MODEL APE 6BB 110T 6618A thru C

ASSY GE 408663
(RUBBER DRIVE)
 DRIVE ASSY, includes
 3 thru 7

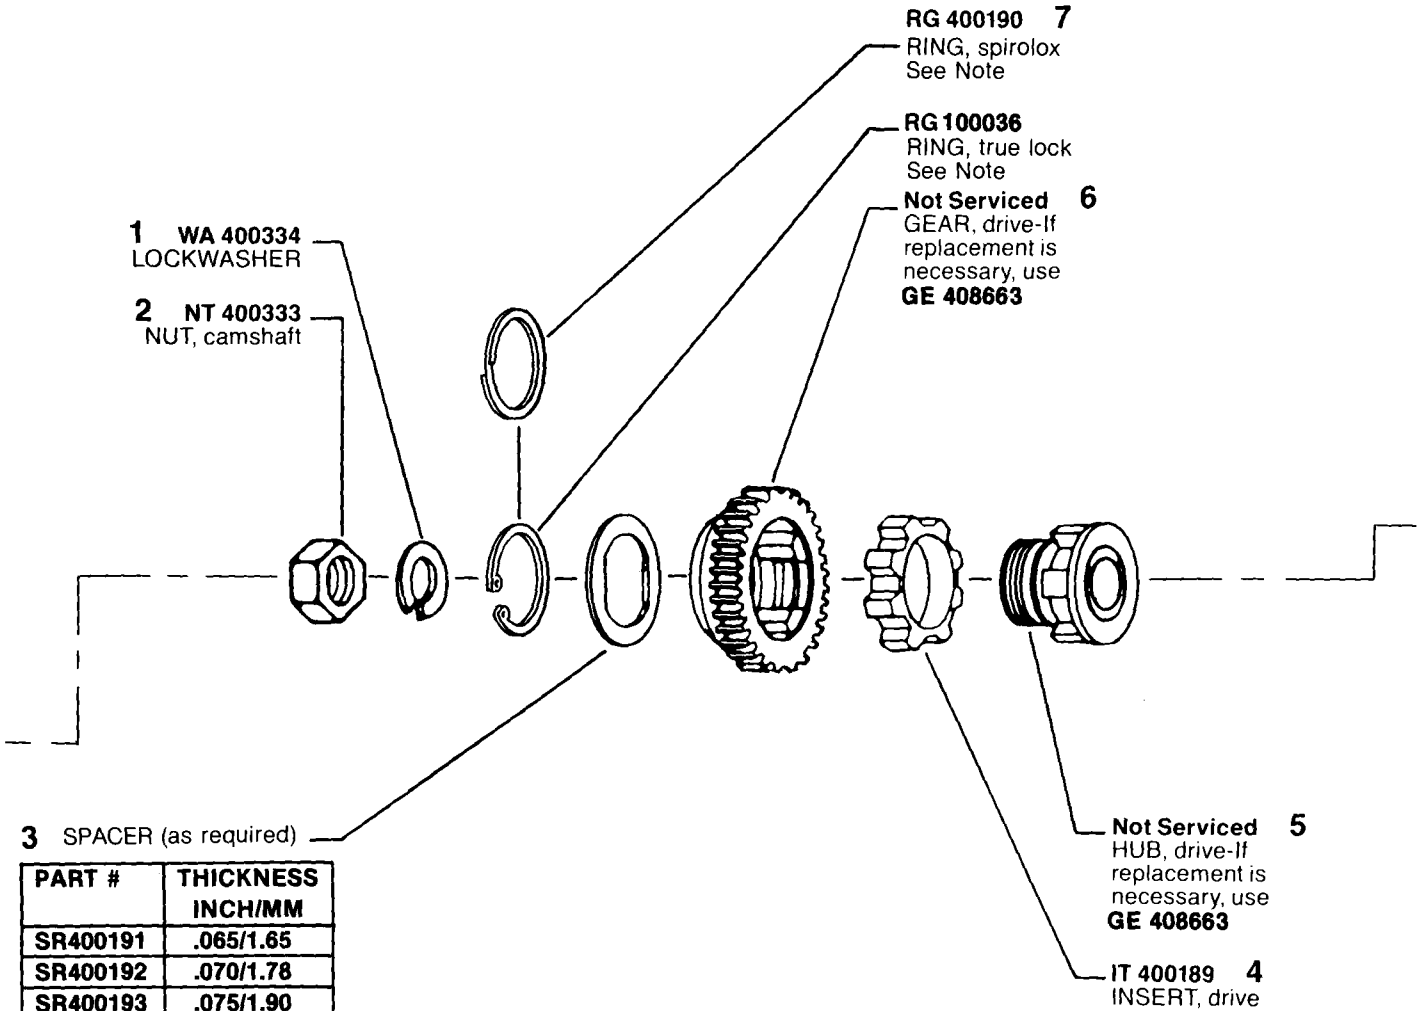
NOTE: When replacing shaft (#23 w/groove) with latest shaft (SH408799 no groove) BG404151 (25) MUST be used. Shaft with groove used BG400118.

#7 NOTE: Earlier rubber drive assy GE 400182 used RG 400190 (Spirolox ring), later assy GE 408663 using RG 100036 (true lock ring). Spirolox & true lock rings are NOT interchangeable.
